CITY OF BLOOMINGTON

WORK SESSION NOTICE

MONDAY, AUGUST 25, 2014, 5:25 P.M.

BACKGROUND: On September 26, 2005, Council approved an Annexation Agreement with the Grove on Kickapoo Creek, LLC. The Annexation Agreement requires the City to pay for oversizing sanitary trunk sewers, water mains and pavements in the Grove Subdivision. The Annexation Agreement does not require the developer to provide any notice of proposed developments, which would allow staff to adequately budget for oversizing costs. Staff submitted budget estimates based upon the attached Grove on Kickapoo Creek Construction Phases Map.

AMENDED PRELIMINARY PLAN

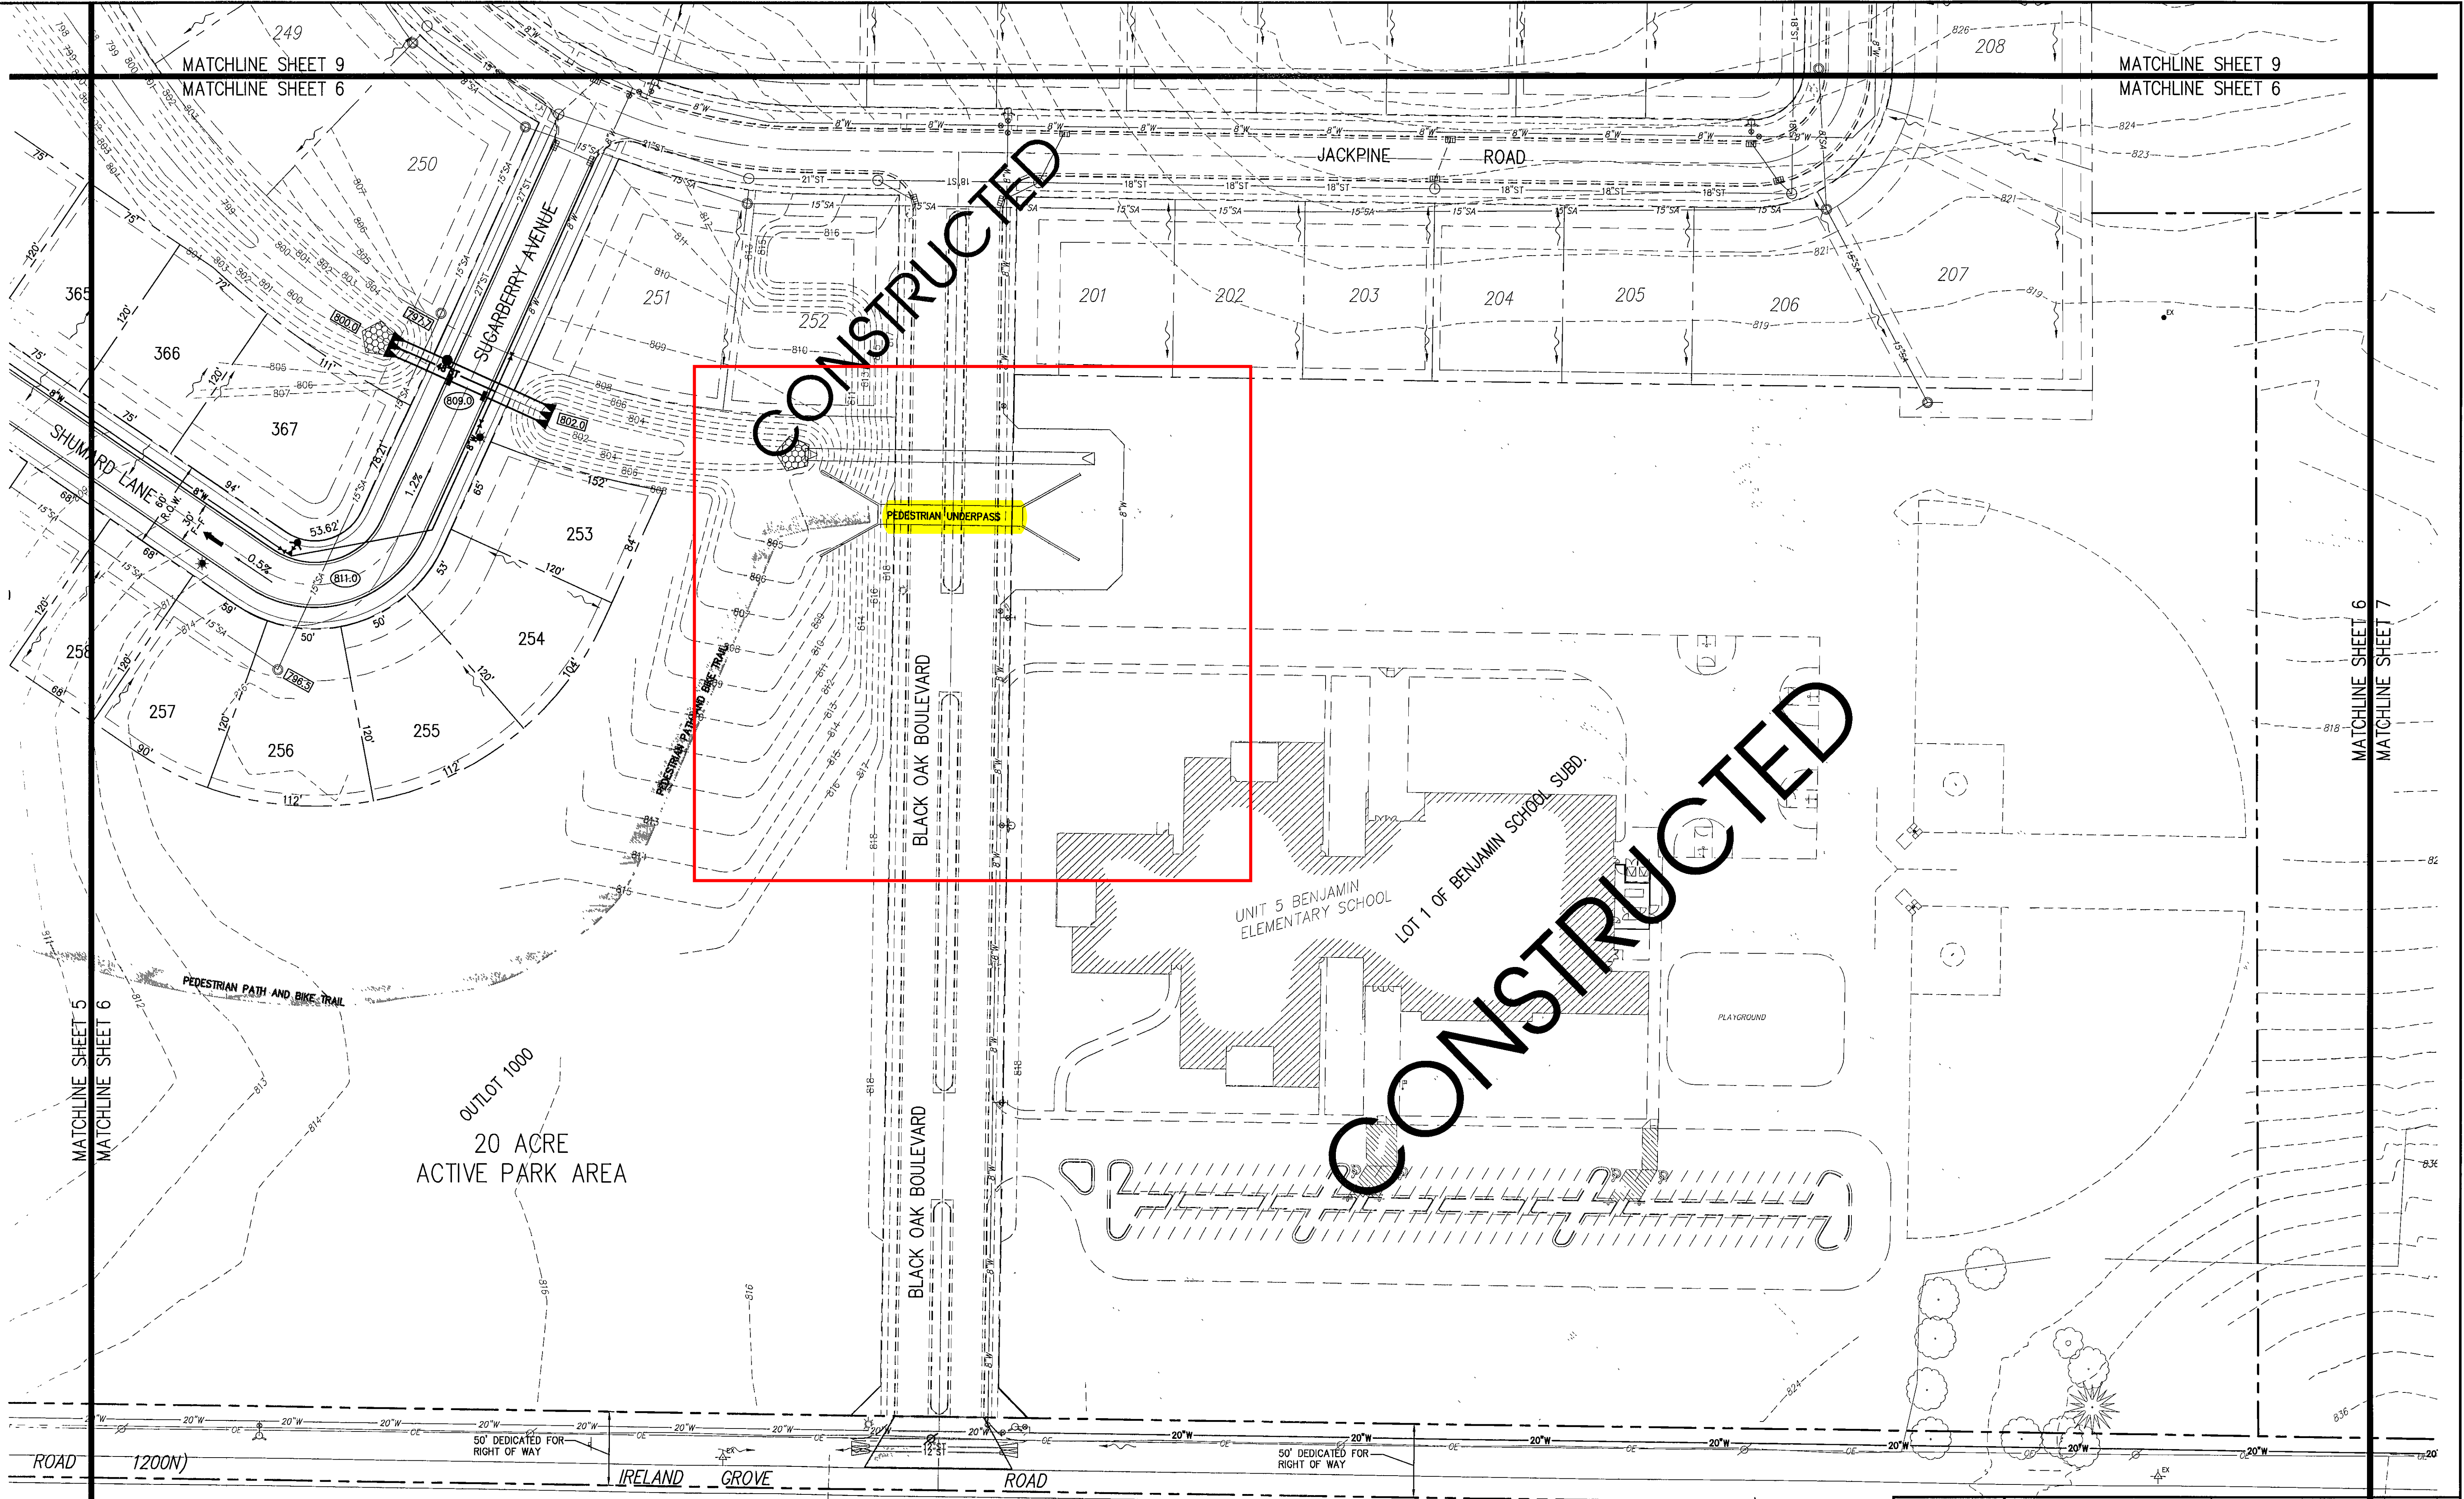
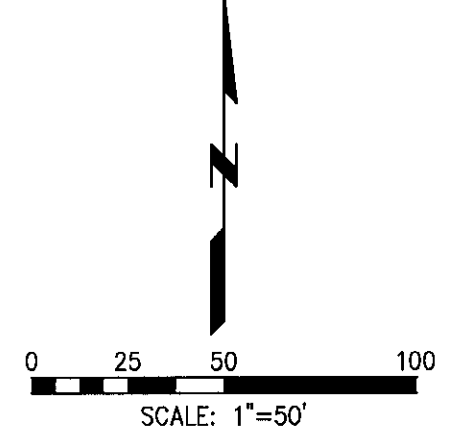
The approved Preliminary Plan for this development clearly depicts a bike/walking trail at the subject pedestrian underpass location.

- D. Please provide information regarding a pedestrian underpass beneath Kickapoo Creek Road. The grades shown do not appear to allow room for pedestrian use.
